Service Bulletin

B0301902 2003-10

SB, 136/141 Adjustment screws for carburetor, 2003-10

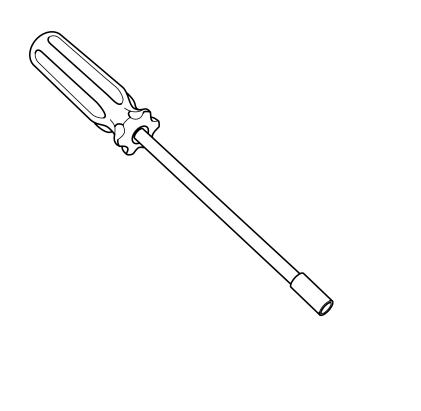
A carburetor without limiter caps for the L- and H- speed jets has been introduced on the above models.

The carburetor has a new type of screw head for the L- and H- speed jets (see picture). The adjustment screws are grooved on the outer edge and will not have a slot in the head.

To simplify the adjustment of the carburetor a special service tool is available.

New part no. 530 03 55-60 **Description**Adjustment screw driver
